TECHNICAL BULLETIN

Subject: SPECTRUM REGULATOR REWORK INFORMATION

IMPORTANT SAFETY NOTICE PRODUCT RECALL

TITLE: REGULATOR HIGH PRESSURE SEAT INSPECTION/STATUS REPORT

Spectrum Regulator Parts Diagram

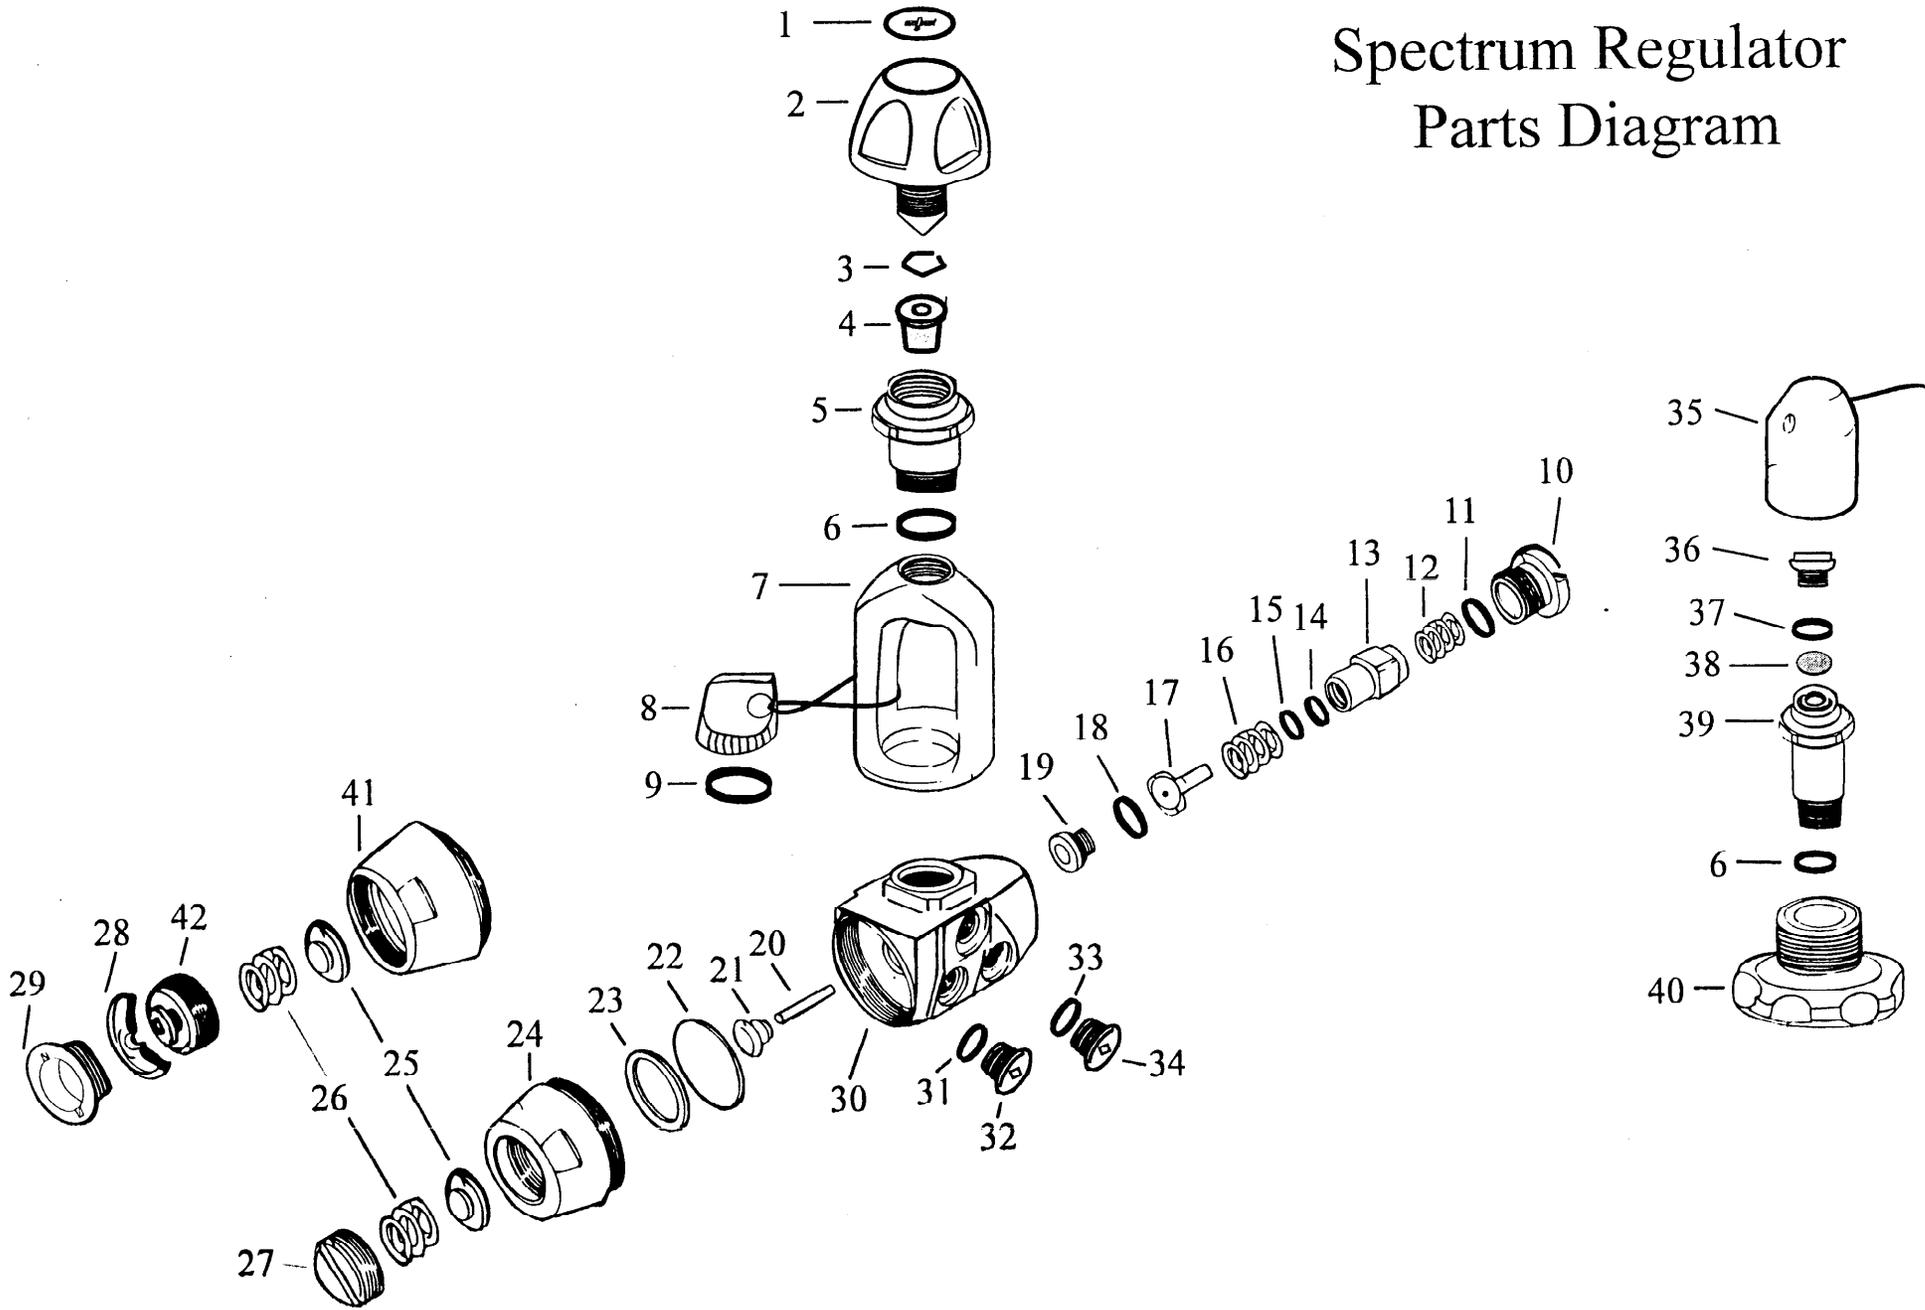
- 1.1) Unscrew and remove the high pressure plug (10) using a large flat blade screwdriver.
- 1.2) Remove the spring (12), spring block (13), high pressure seat spring (16), high pressure seat (17), and pin (20). This can be done by turning the first stage over to allow all parts to fall into the palm of your hand or on to a table top.

- 2.1 Under a bright light, visually inspect inside the first stage for any evidence of Loctite residue or other contaminants. Pay particular attention to the seat crown (19) and the area around the seat crown. If there is evidence of Loctite residue on the seating surface the entire regulator and parts should be returned to Sea Quest for rework.

- 2.3 Replace the old HP seat with the new HP seat. You may note that the new HP seat is different in appearance. Although either type may be used in Spectrum regulators, the new style offers improved durability and wear characteristics.

- 3.1 Install the pin (20) into the high pressure side of the first stage making sure it is centered in the seat crown (19).
- 3.2 Install the new high pressure seat part so that it fits over the pin. Make sure the pin engages the hole in the high pressure seat. Use the Spectrum parts diagram as a reference for proper orientation of HP seat.
- 3.3 Re-install the HP seat spring (16), the spring block (13), and spring block spring (12) into the high pressure side of the first stage.
- 3.4 Screw the HP cap (10) in and tighten with large flat blade screwdriver until hand tight.
- 3.5 Place a drop of blue torque seal on the high pressure plug (10) at its perimeter near but not over the serial number.
